Subject: S-Series Platforms: 34in. x 54in., 32in. x 51in.
Applicable Products: S1205, S2005, S2010, S5005, S5010, S5505, S5010
Effectivity: 6/24/2014

This bulletin provides a brief description of a technical issue related to the inspection and possible replacement of the platform assembly of certain S-Series wheelchair lifts.

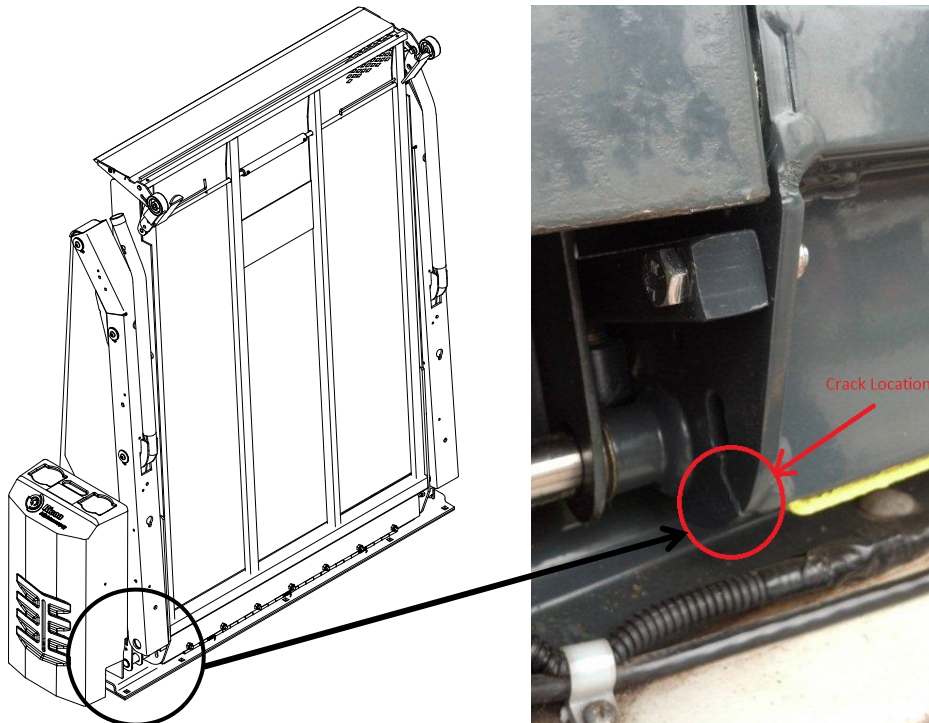
Under certain conditions the side plate of the larger platforms included on the subject S-Series model wheelchair lifts can exhibit cracking while in the stowed position which, if left unchecked can propagate to the point where separation of the rear portion of the side plate occurs rendering the lift inoperable and possibly unsafe to use.

The cracking as illustrated has been observed on less than 5% of the subject population and appears to be caused by a combination of factors including but not necessarily limited to, incomplete stowing of the lift and/or maladjustment or otherwise malfunctioning of the stow lock device combined with a violent side- to- side movement that might be associated with traversing curbs, speed bumps and other variable road conditions, especially at higher speeds.

If cracks are found, the platform must be replaced as soon as possible. Use the following part numbers for the associated model numbers.
